## **Site**

134 Fairy Glen Rd, Collinsvale, TAS 7012

## **RFI Response**

GLENORCHY CITY COUNCIL  
PLANNING SERVICES  
APPLICATION No. : PLN-26-073  
DATE RECEIVED: 31 March 2026

### OWMS: Wisconsin Mound

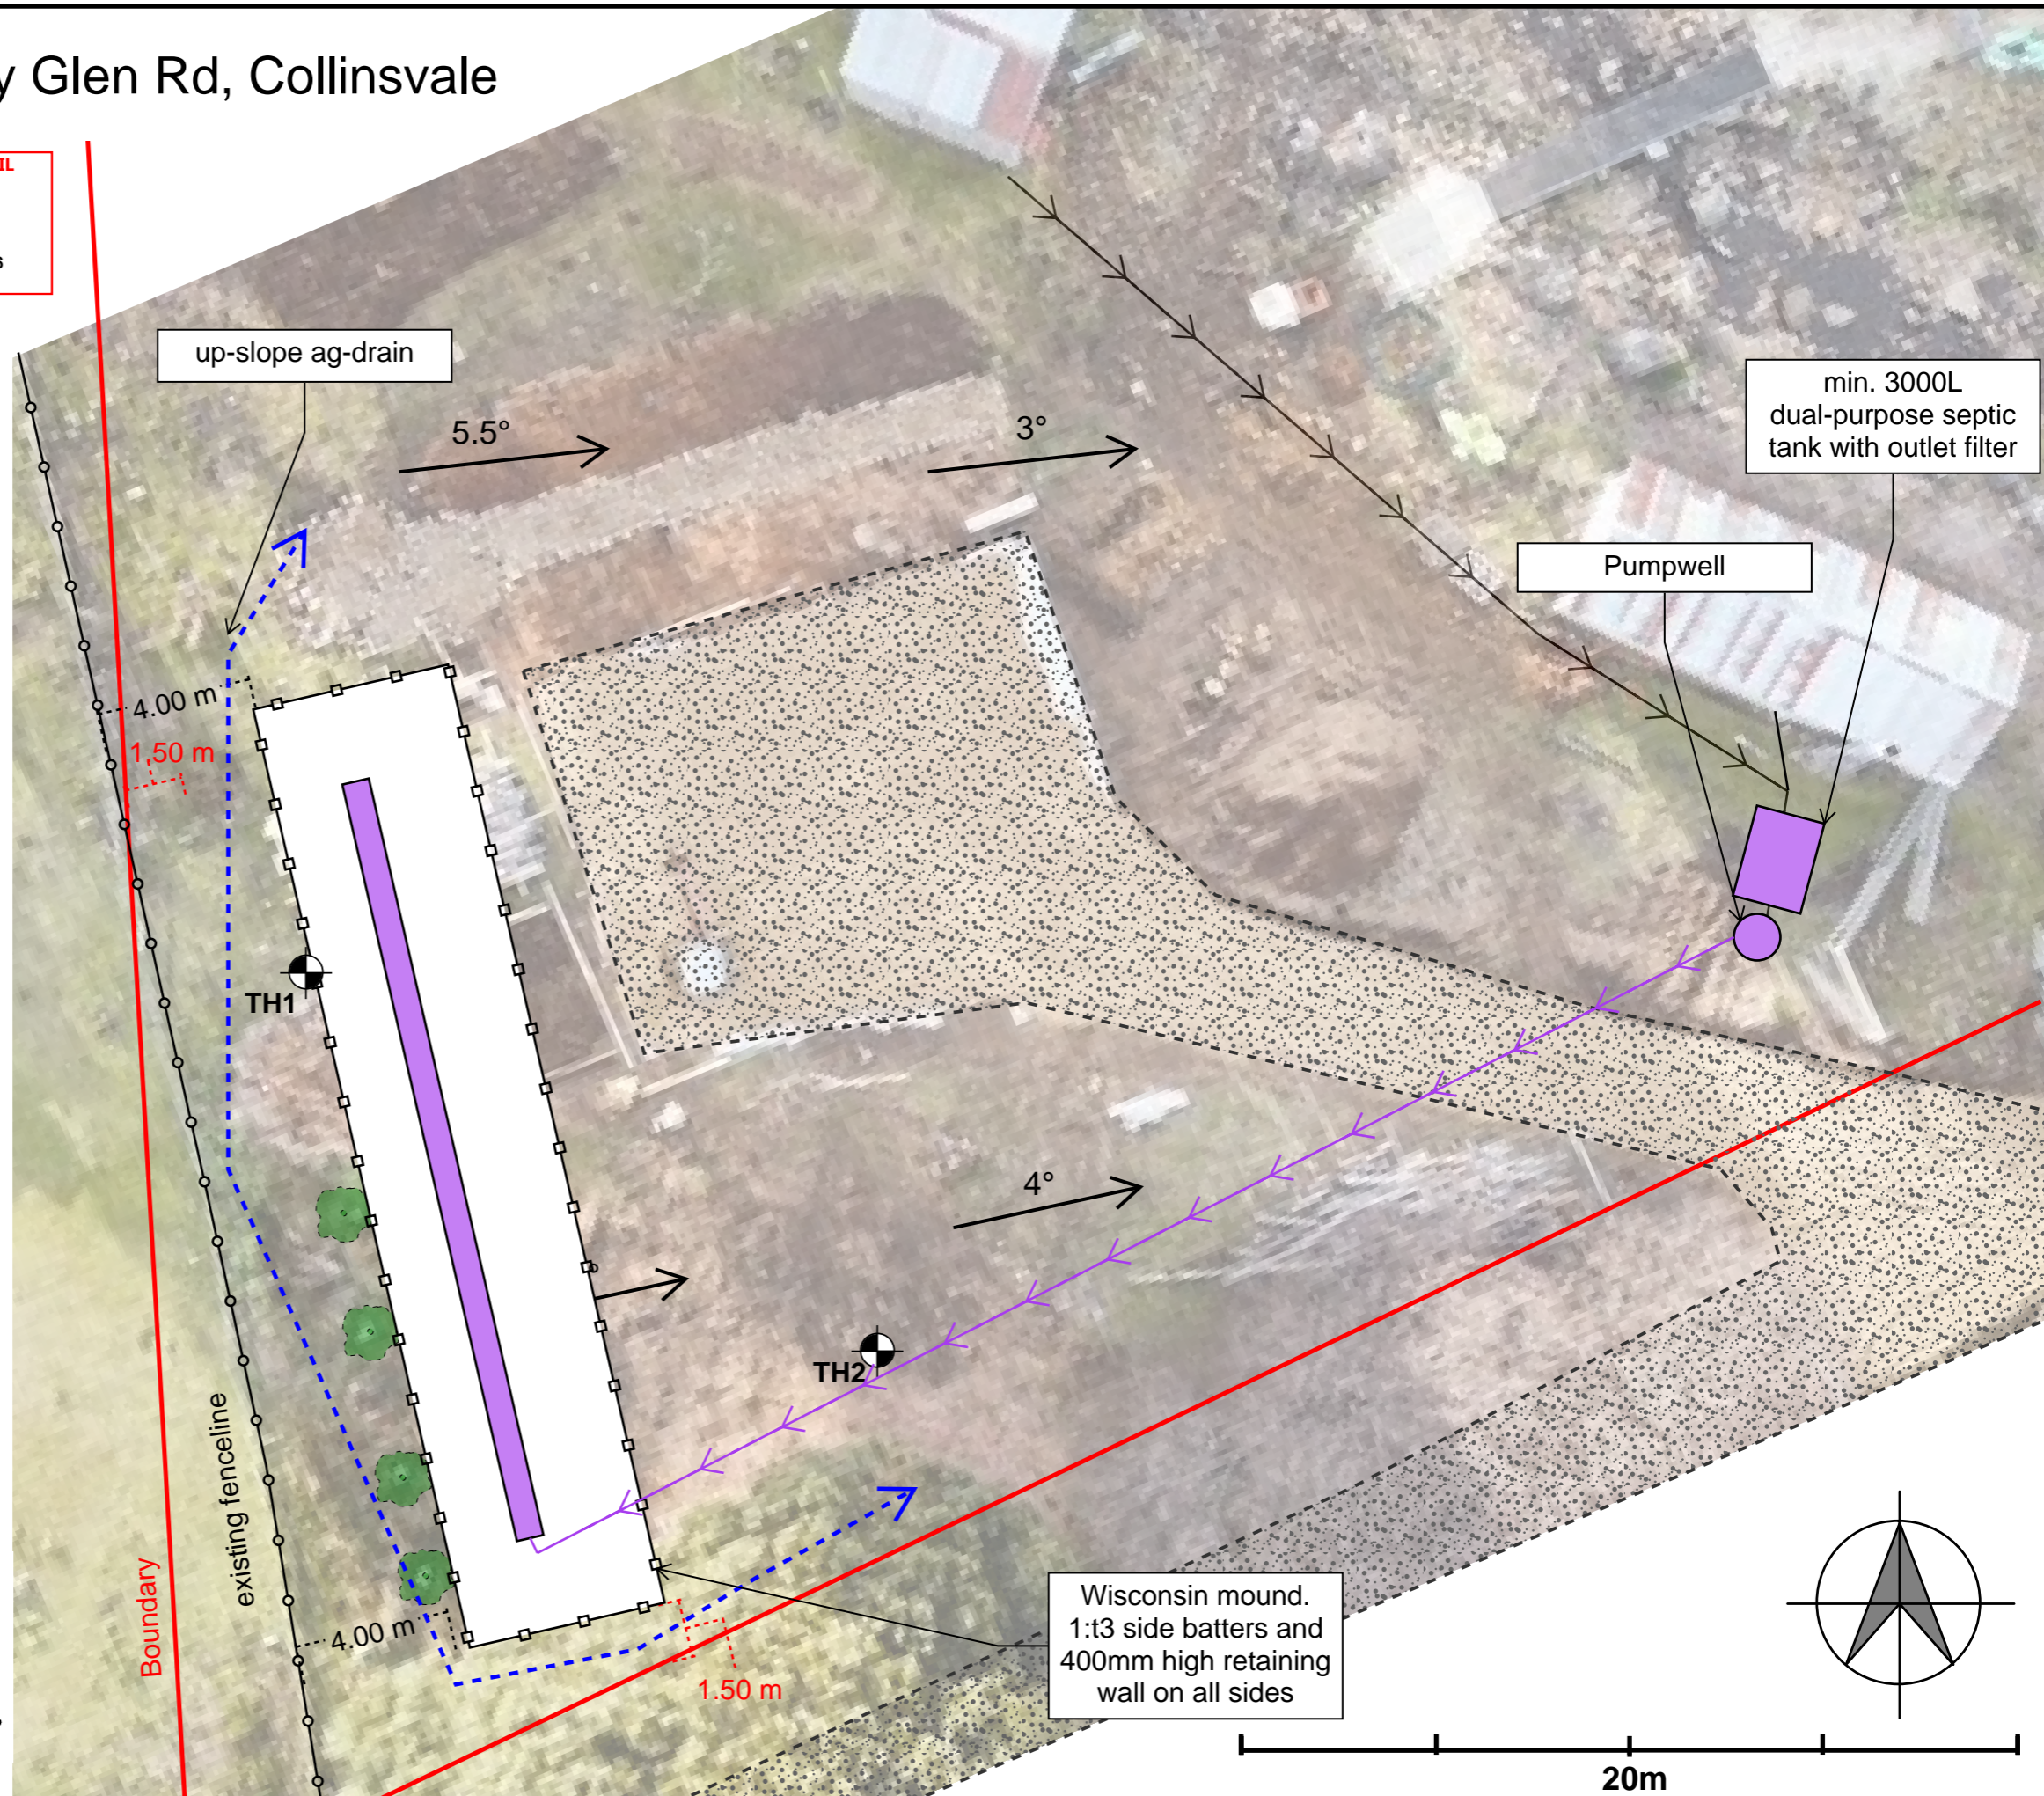
<b>Heritage Tasmania</b>	
<b>RFI</b>	<b>Applicant Response</b>
<b>RFI 1</b> <b>Site plan</b> The proposed onsite wastewater treatment system is not included in the site plan. Please amend the scope of works shown on the Site Plan, particularly items identified in the Legend	The onsite wastewater treatment system outlined in the WW – Site Plan – 134 Fairy Glen Rd submitted in the original proposal has now been incorporated into the architectural site plan.
<b>RFI 2</b> <b>Small hut</b> Please clarify and justify the proposed removal of rafters for the skylight. The demolition plan shows one rafter removed whilst the south elevation plan shows all (two) rafters removed. It is recommended that existing rafters be retained, with the skylight installed over them where possible.	The removal of rafters outlined in the demolition plan was a mistake in drafting. No rafters or beams are proposed for removal and the architectural drawings have now been updated to reflect this.

New 3000 L dual-purpose septic tank with outlet filter, gravity feeding to pump well with min. 800 L capacity. Pump-dose to the Wisconsin mound. Set float switch to pump at **102 L per cycle for 70 L** mound doses.

Deep rip the ground surface below the planned mound. Orientate so the long dimension follows the natural contour. Mound to be constructed parallel to, and approx 4 m offset, the existing up-slope fence line.

Basal dimensions of the mound: 24.8 m long x 5.15 m wide. 400mm high retaining wall required to reduce mound basal area (due to site area constraints - effective DLR at basal area remains < 5mm/day)
